West Harptree - Additional notes and amendments 1st October 2025

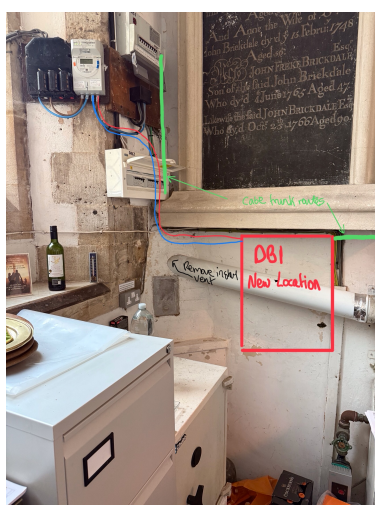
Lady Chapel wiring route with amended heater location to benefit Piano
